Snowy 2.0 Exploratory Works Modification 2

Response to Submissions Report

Prepared for Snowy Hydro Limited
January 2020

Snowy 2.0
 Exploratory Works - Modification 2
 Response to Submissions
 Figure 3.1

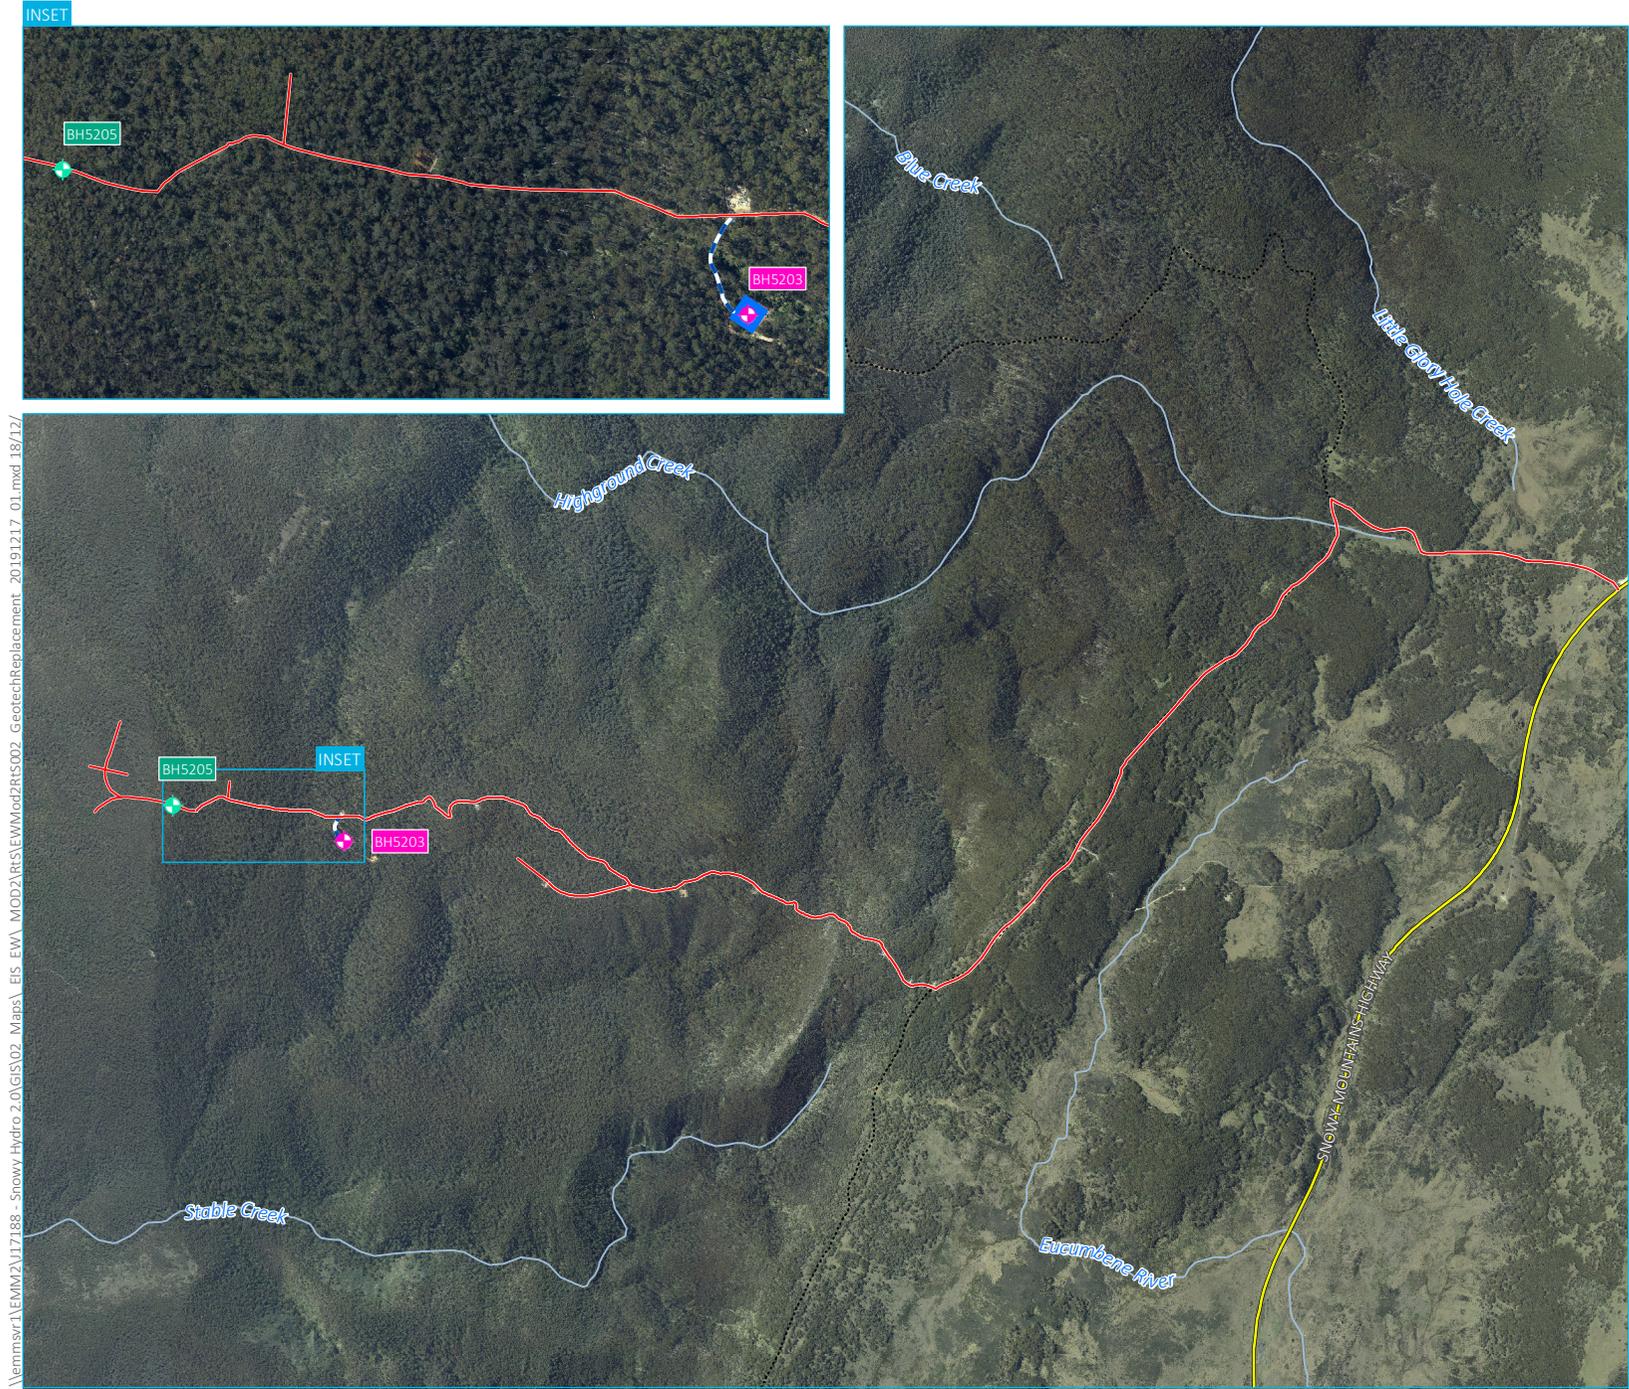
- Removal of approved borehole BH5205 and replacement with BH5203, to be located on a previously disturbed drill pad and access road off the Marica Track;
- Clarification of the proposed height for vegetation trimming on Lobs Hole Ravine Road South; and
- Development of a protocol for post-approval vegetation removal in consultation with BCD.

The location of the existing approved borehole to be removed from scope (BH5205) and the location of the replacement borehole (BH5203) are shown in Figure 3.1.

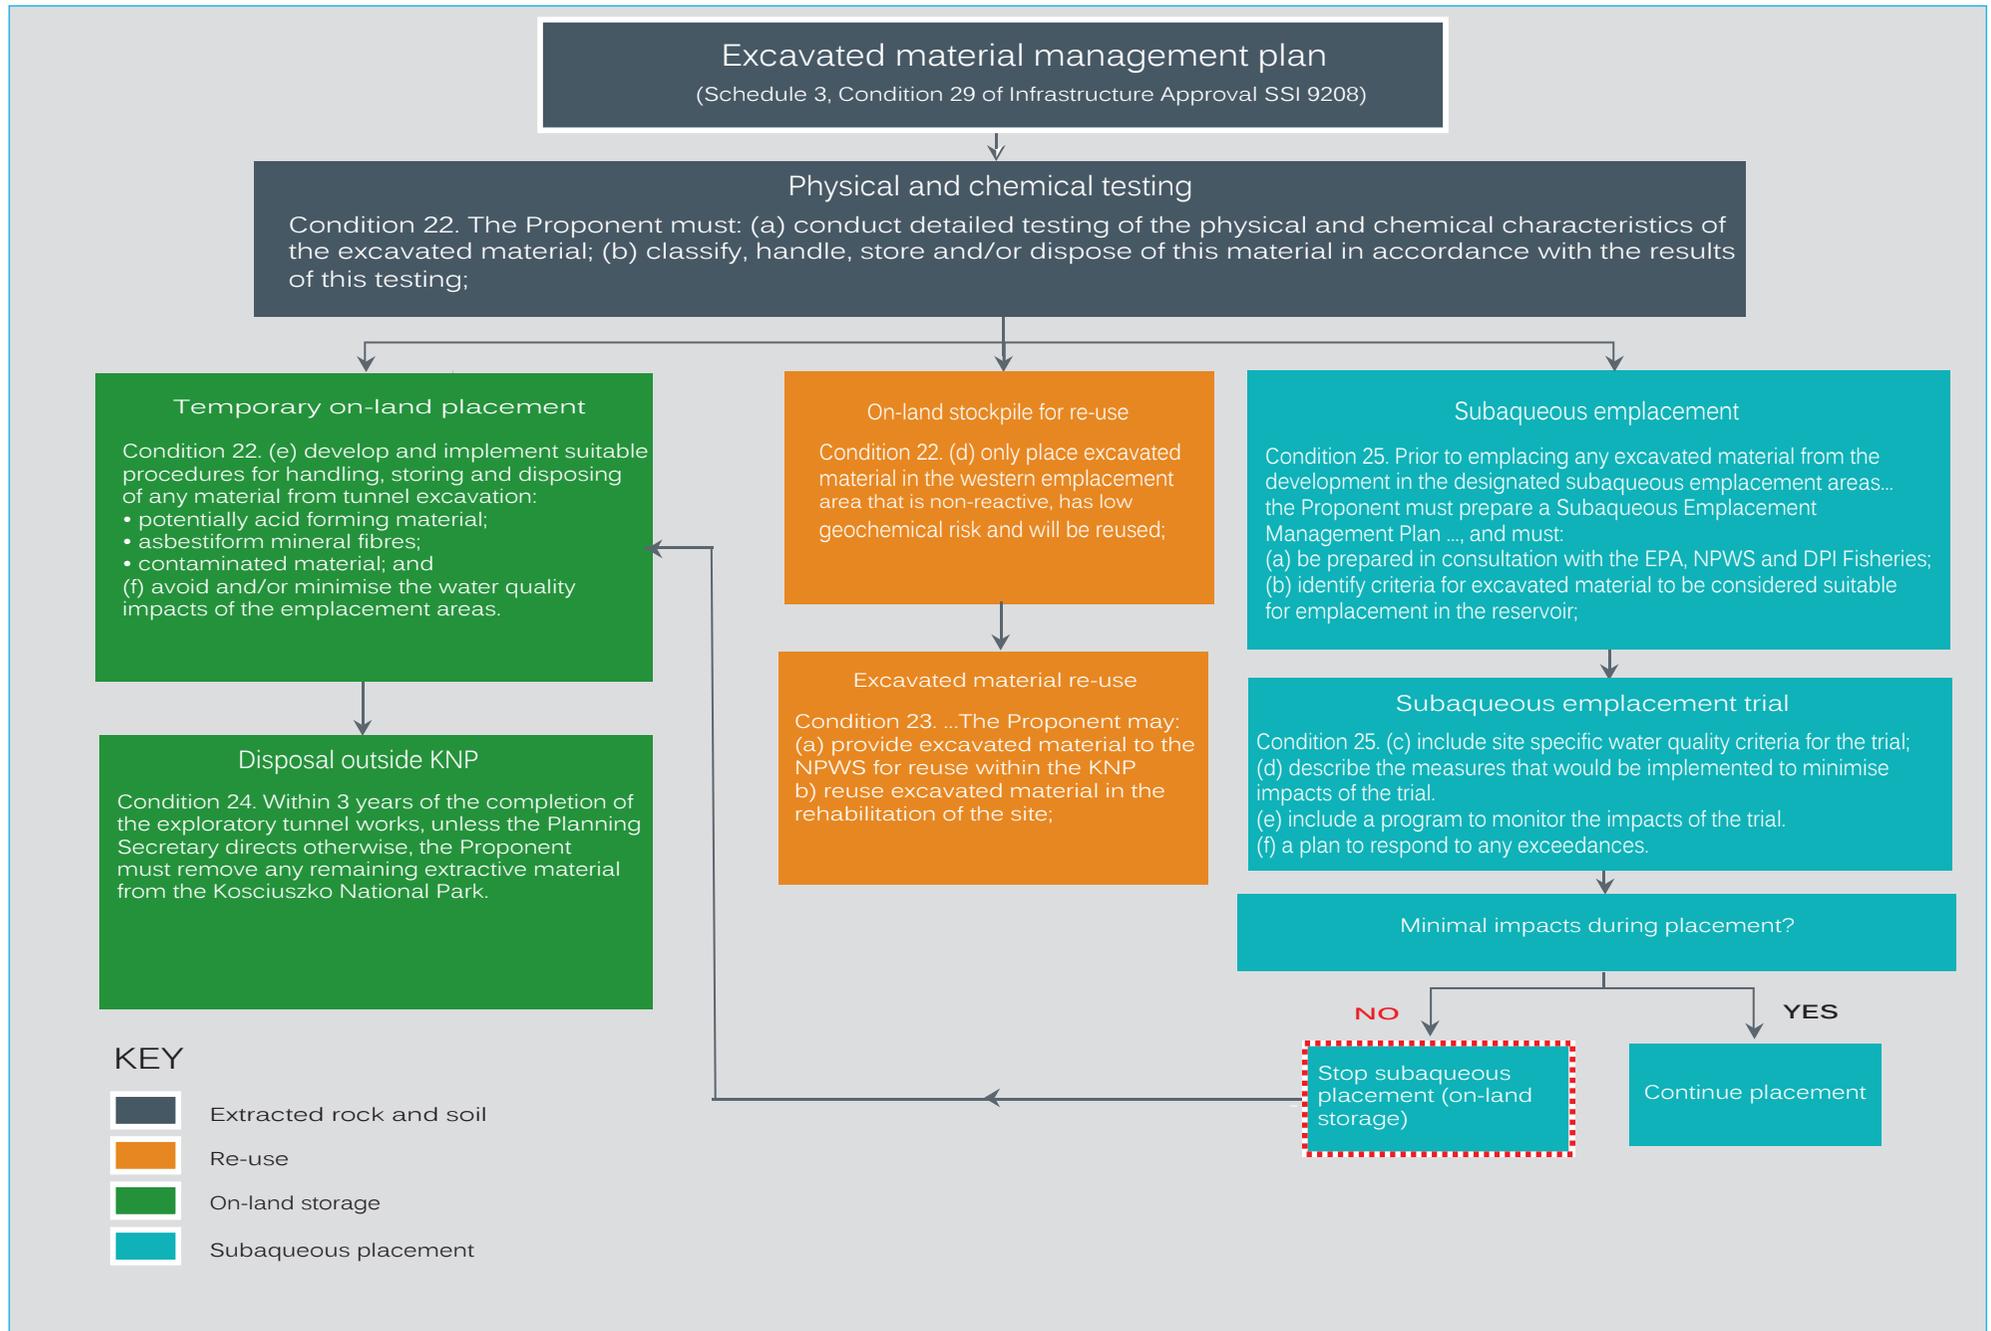
Modification Report section 3.2 identifies a change in methodology from drill and blast to the use of a tunnel boring machine.

- *Clarify the extent of difference in the composition of the spoil generated by the two methodologies.*
- *Undertake a full environmental assessment of potential ground and surface water impacts resulting from the change in methodology.*
- *Undertake a full environmental assessment of potential terrestrial and aquatic impacts resulting from the change in methodology.*
- *Undertake a full assessment of potential water quality impacts to Talbingo Reservoir resulting from the changed spoil composition and approved sub aqueous placement.*
- *Recommended condition of consent*
- *Tunnelling works are not to commence until a Subaqueous Emplacement Management Plan is prepared in consultation with EPA and completed to the satisfaction of the Planning Secretary and NPWS*

Once material has been excavated from the exploratory tunnel, it is subject to testing of its physical and chemical characteristics. The conditions of approval then require this material to be then classified, handled, stored and/or disposed of in accordance with the results of this testing. This means that the material will either be re-used, placed on land or placed subaqueously within Talbingo Reservoir as part of a trial program. A flow chart showing the approved process for excavated rock management and the relevant conditions of consent is provided in Figure 4.1.

The existing conditions of approval provide strict controls and processes for excavated material emplacement and its management. This process is outlined in the flow chart provided in Figure 4.1 and also in the corresponding conditions of approval, Schedule 3, Condition 22 and 23 which state:

Figure 4.3 Indicative swept path for Monaro Highway/Sharp Street and its intersection with Bombala Street

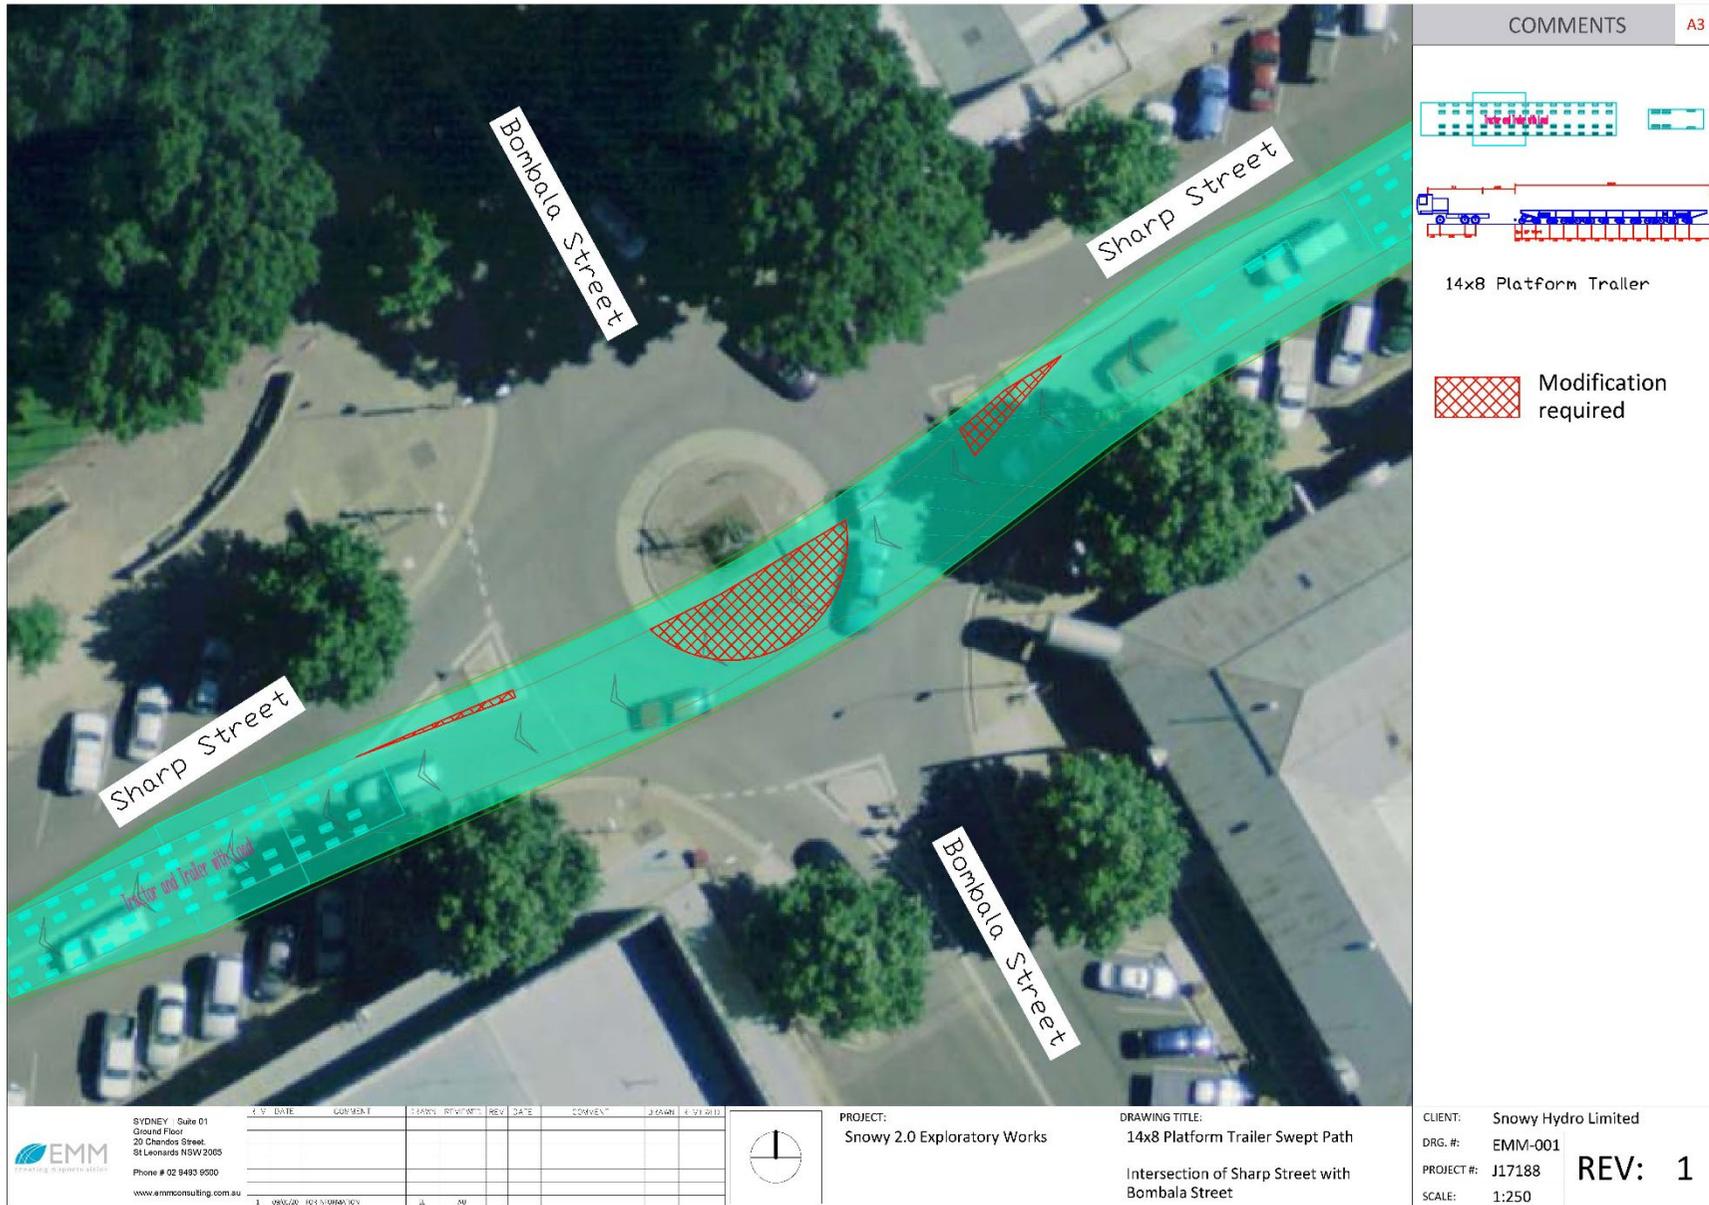
Snowy Mountains Highway with Lobs Hole Ravine Road (North)	Nil	TfNSW is concerned with the anticipated vehicle movements from the Snowy Mountains Highway into Lobs Hole Ravine Road (North) and believes that an appropriate treatment has not been identified at this intersection (e.g. BAL treatment in accordance with Figure 8.2 Austroads Guide to Road Design Part 4A as well as sealing for a minimum of 20m into Lobs Hole Ravine Road (North) to prevent the transfer of gravel/mud onto the Snowy Mountains Highway). A concept design and associated environmental assessment for the upgrade to the existing treatment is required. Refer to additional comments under the headings 'Strategic/Concept Designs' and 'Environmental Impacts' below.
TfNSW requests the submission of additional information to address above comments.

Indicative swept path diagrams are provided in Figure 4.3 and Figure 4.4 below which show the indicative path of the largest OSOM vehicle movement through the two intersections.

The indicative swept path assessment provided in Figure 4.3 and Figure 4.4 shows that some modifications would be required for the roundabouts, refuge islands and street signage.
